**DEVIATION REQUEST
AND DECISION FORM**

Project Name : Saddlehorn Ranch – Filing 3
 Schedule No.(s) : 4300000602
 Legal Description : SEE ATTACHED – Exhibit C

A deviation from the standards of or in Section **ECM section 2.3.4 / Table 2-14** of the Engineering Criteria Manual (ECM) is requested for the Curtis Road cross-section.

K-VALUE VARIANCE EXHIBIT

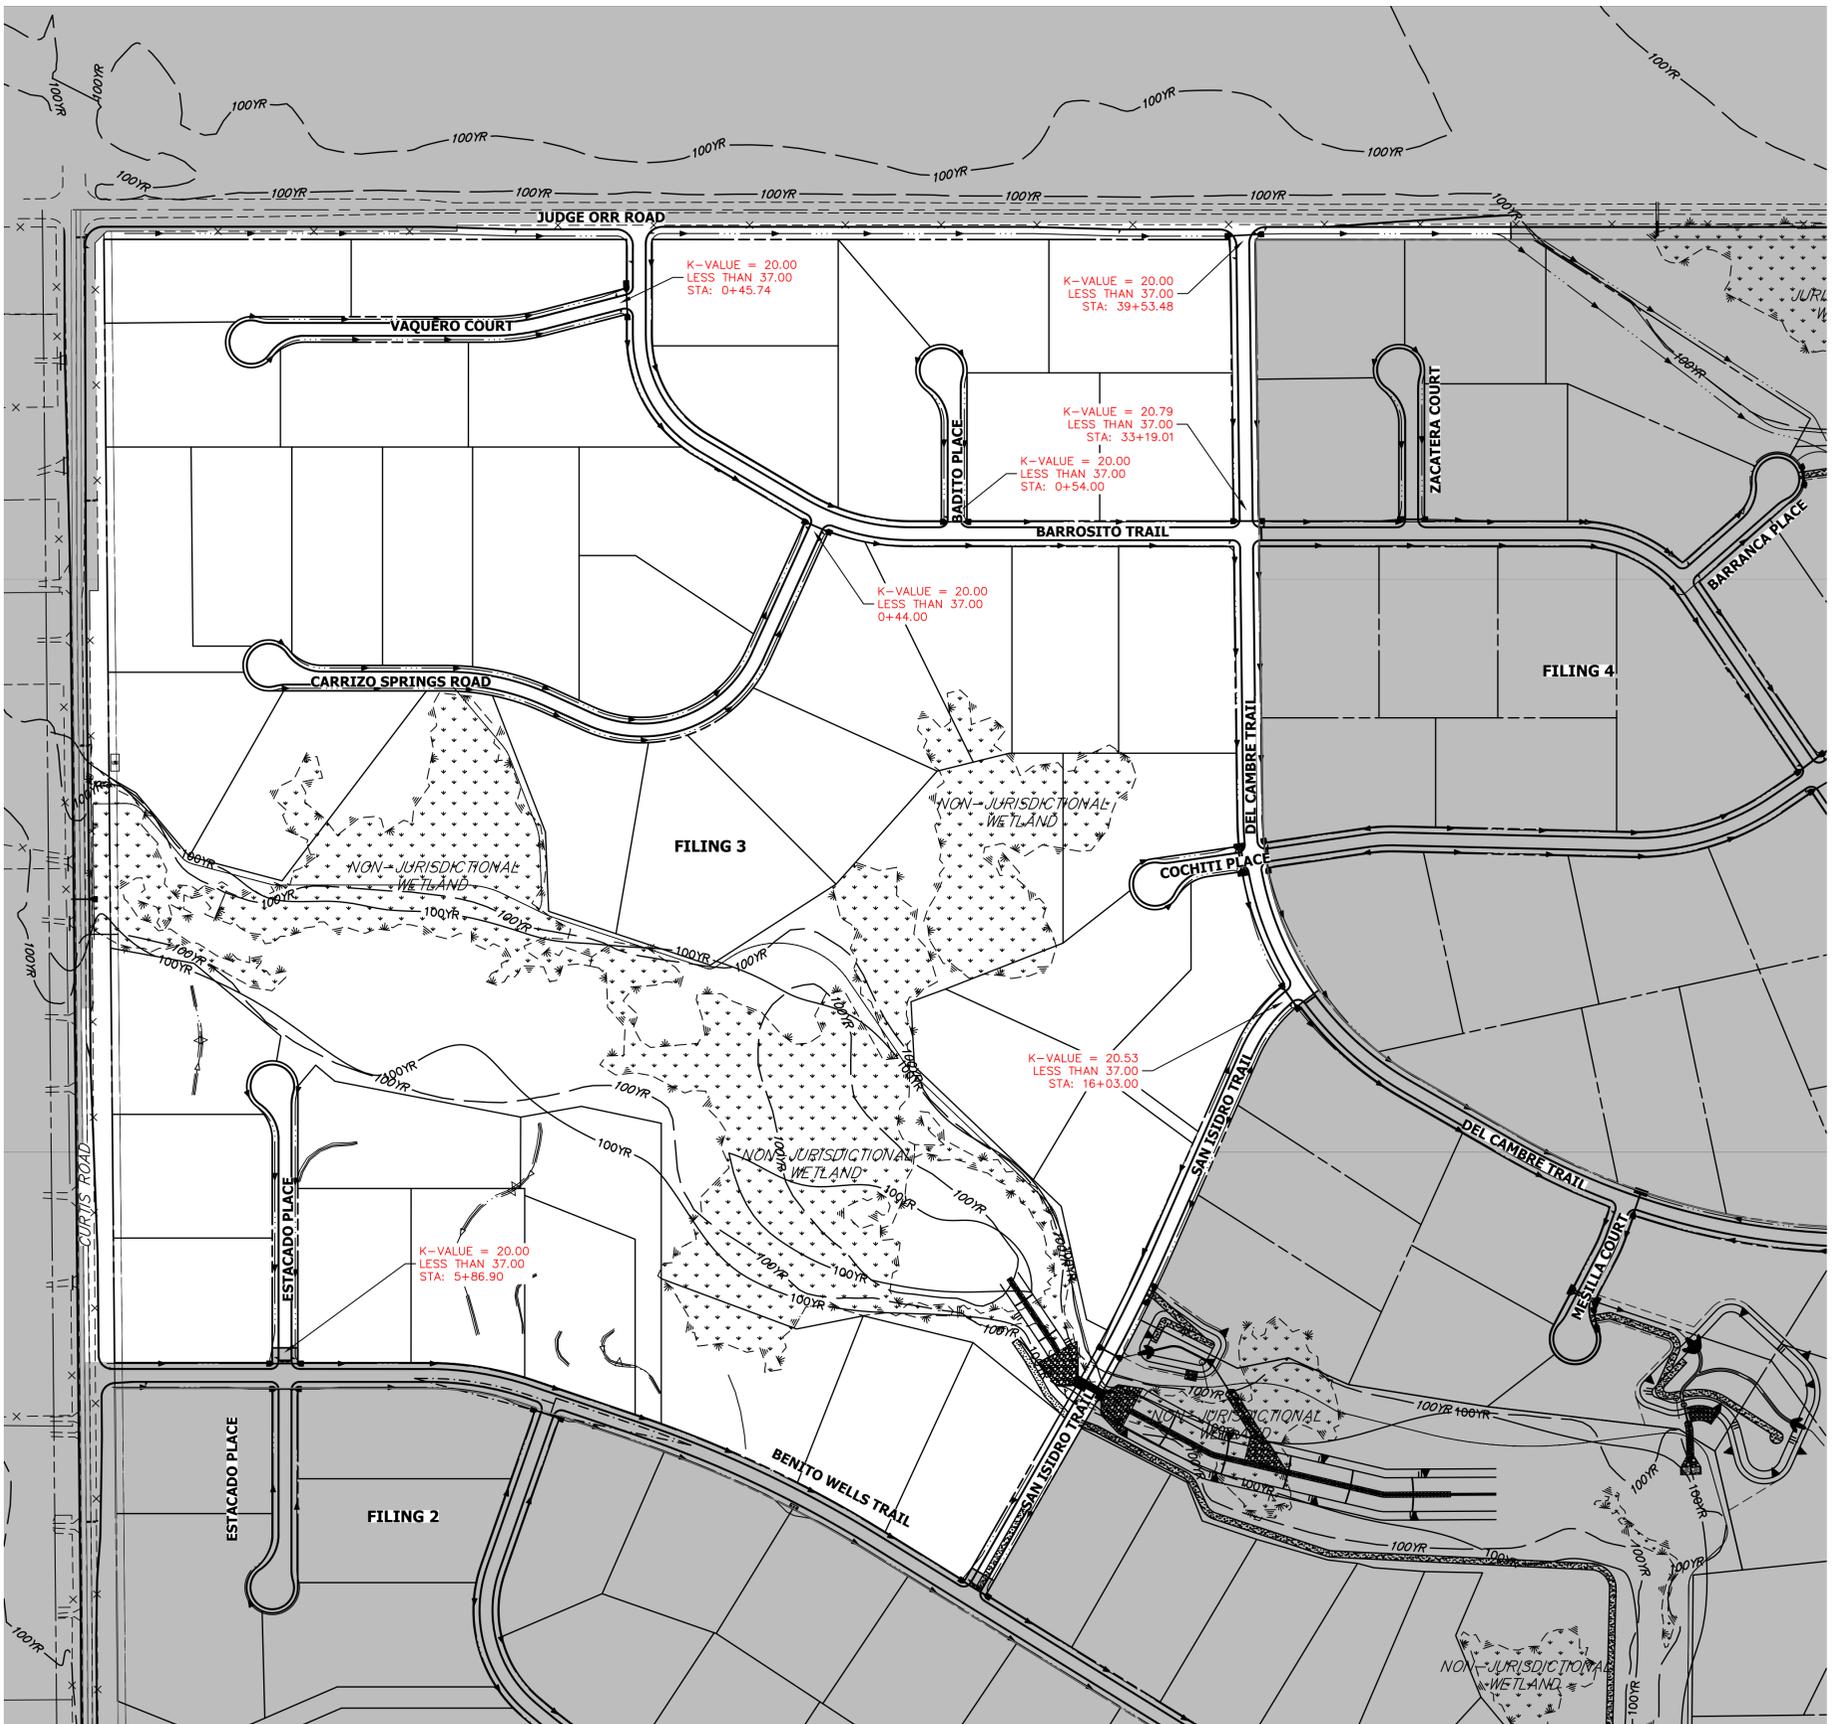
Criteria for K values of a sag curve with a design speed of 30 MPH is 37, per Table 2-14 of the El Paso County Engineering Criteria Manual. The following request will be to deviate from this minimum K value and use a K value of 20 for sag curves at intersections with stop conditions.

In order to construct the roadside swales with adequate longitudinal slopes, the K value for stop condition intersections has been reduced from 37 to 20. This allows the swales at these intersections to maintain adequate depths and slopes as drainage is conveyed through the intersection.

For design speed limits of 30 MPH, a sag curve requires a K-value of 37, per Table 2-14 of the ECM. This deviation proposes a reduction of this K-value for stop-controlled intersections only. This reduction allows the roadside drainage swales to maintain an appropriate longitudinal slope to adequately convey drainage away from the intersections.

2.3.4 / Table 2-14

This request has been determined to have met the criteria for approval. A deviation from Section _____ of the ECM is hereby granted based on the justification provided.
